13 July 2021

RE: Mayfield West Waste Facility-Mod-1 (SSD-7698-Mod-1)
Request for additional information

In response to your RFI letter (09/07/2021), please find below further information addressing the Department's issues.

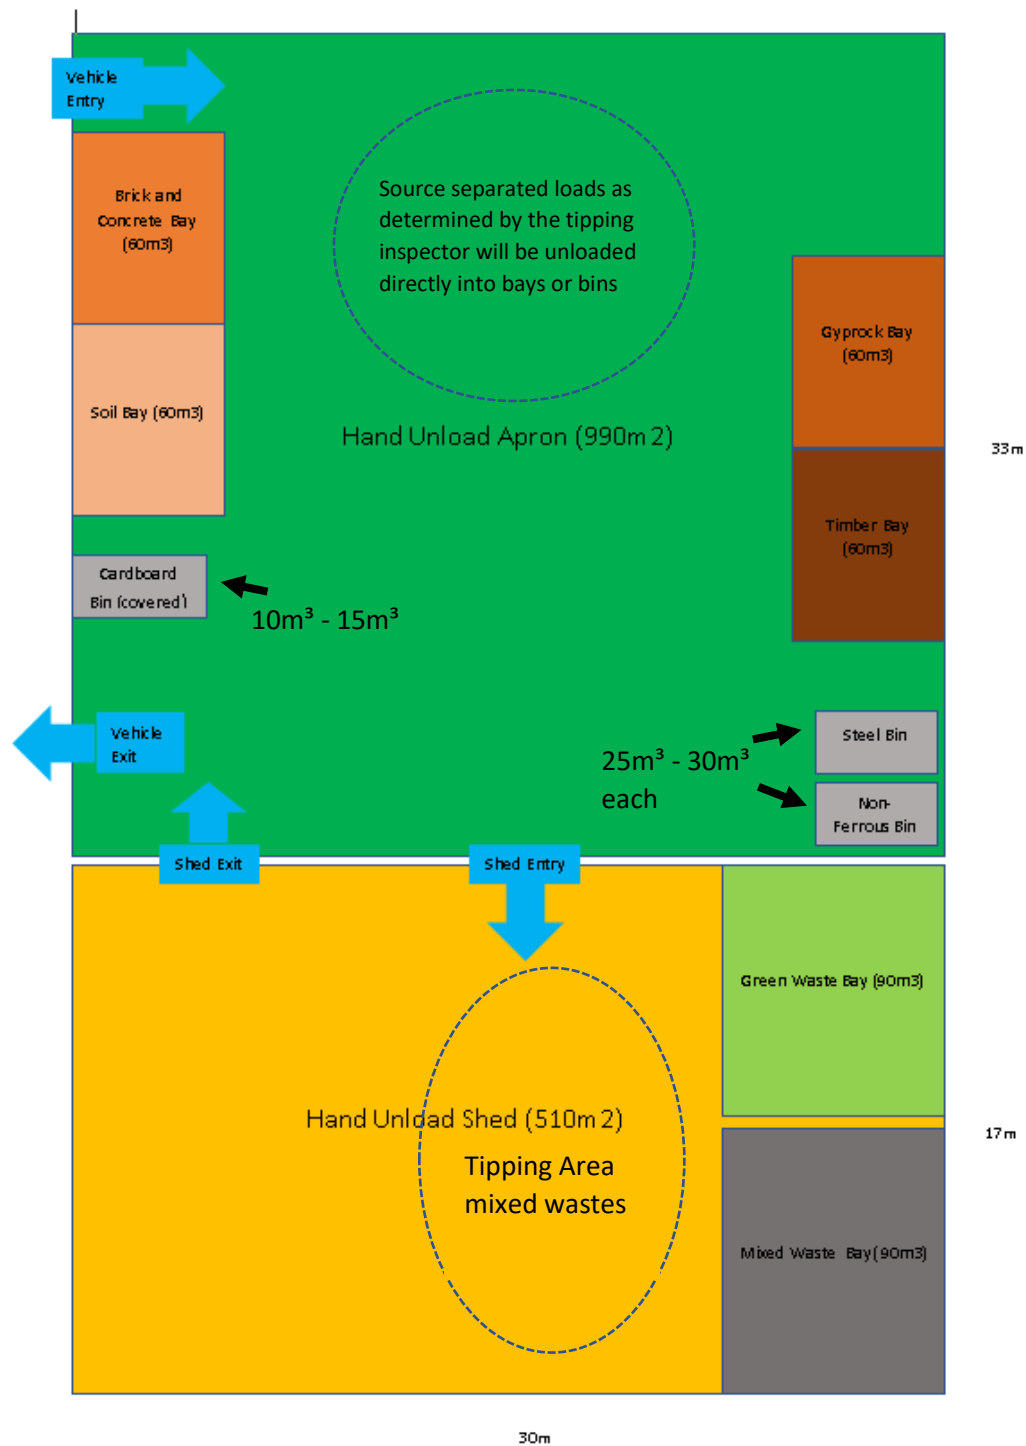
- *Show where hand unloading would take place in Figure 5 Conceptual layout plan for proposed hand unload shed and apron area of the Modification Report.*

Benedict response: See diagram.

Benedict response: Light waste will be stored in the shed Mixed Waste bay coloured grey on the Figure 5 Conceptual layout plan for proposed hand unload shed and apron area'. The sizing for the bins will be:

Mayfield West Recycling Facility - proposed modification

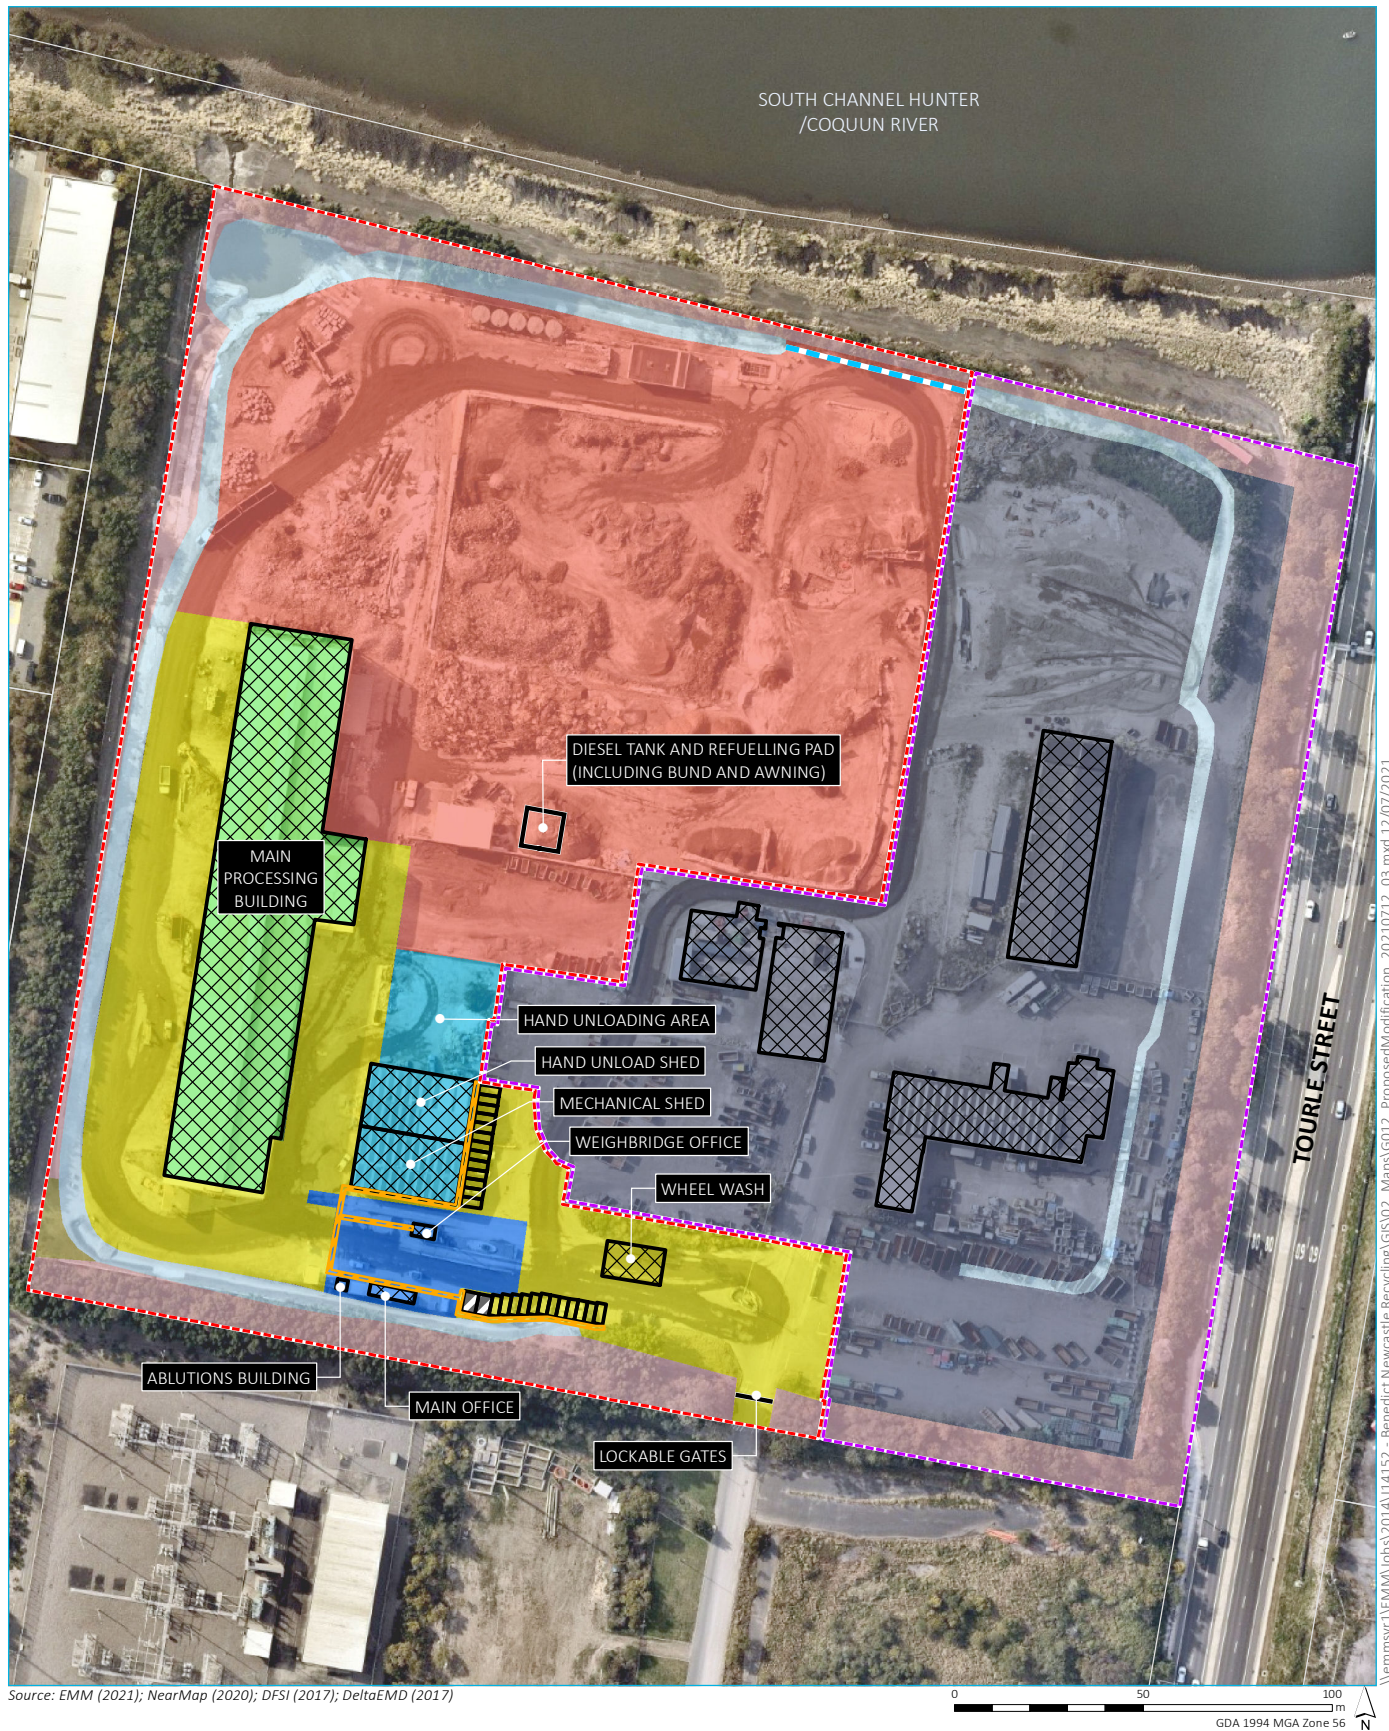
- Provide an updated Development Layout Plan (Appendix A of SSD 7698)

Benedict response: See revised Development Layout Plan attached to this response.
